Issue: Enabling I/O Wait States Generator on SSI or HA-8-3-1 boards.

# Z80 V3.x rework:

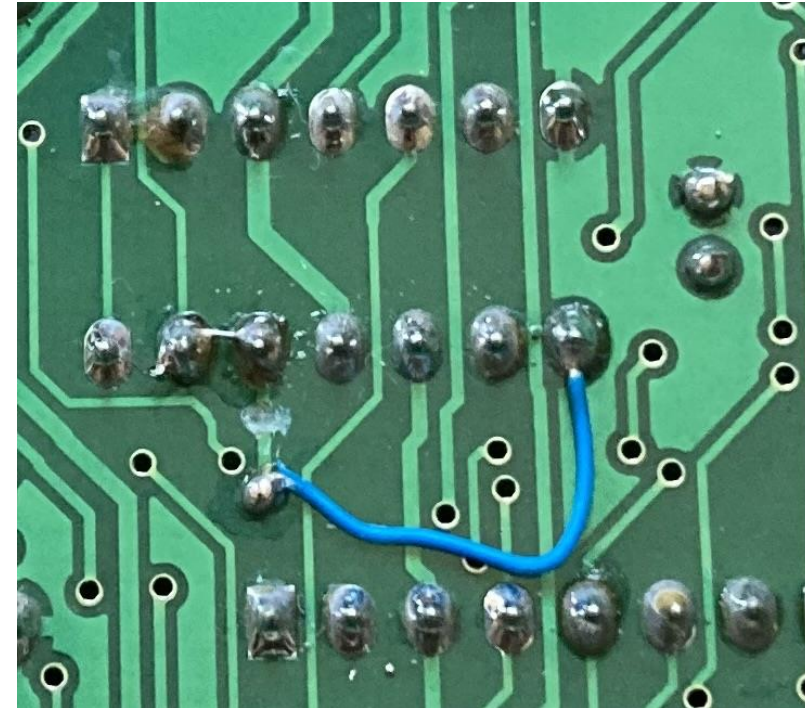
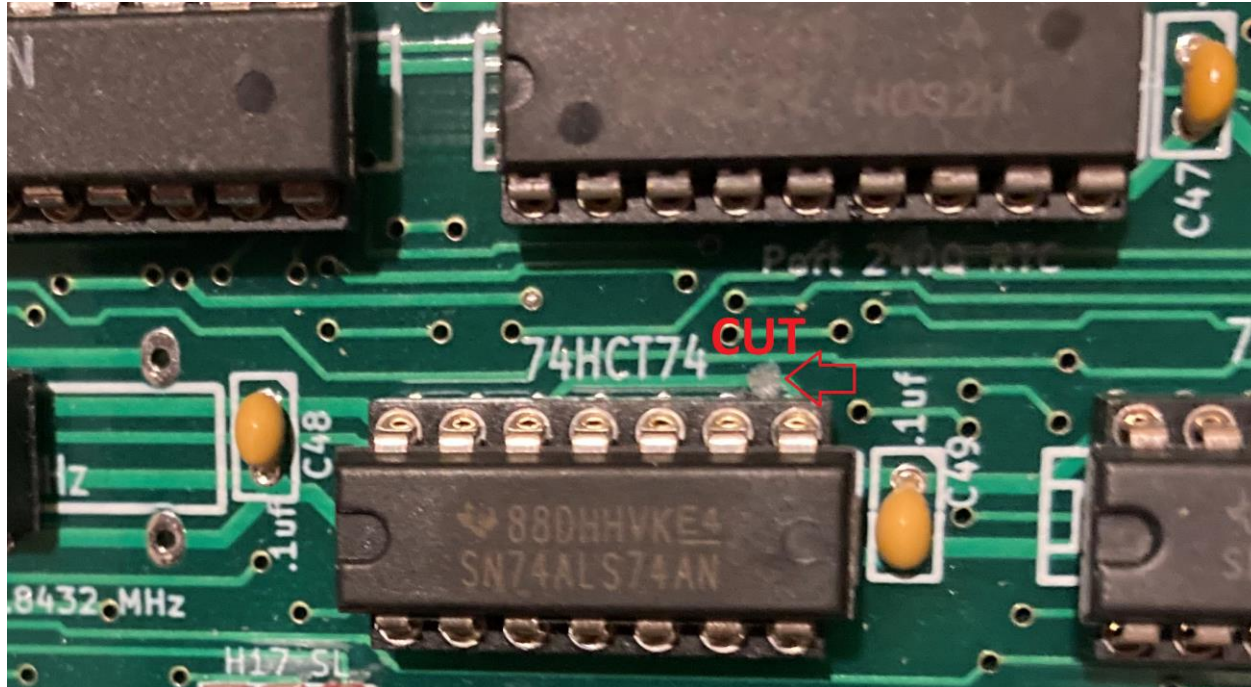
Delayed BWR\_L signal circuit produces multiple write pulses in a given machine instruction cycle when used with any device that inserts I/O wait states. That includes the SSI board or the HA-8-3-1 board with the I/O wait state generator enabled, as well as the Trionyx Z-H8 CPU.

- ✓ Cut trace between pins 8-12 on U112 side 1.
- ✓ On IC U112 side 2 bridge pins 12-13.
- ✓ On IC U112 side 2 cut trace on pin 12 as shown.
- ✓ On IC U112 side 2 solder wire from pin 8 to via as shown. Clean via so that it is easy to solder.
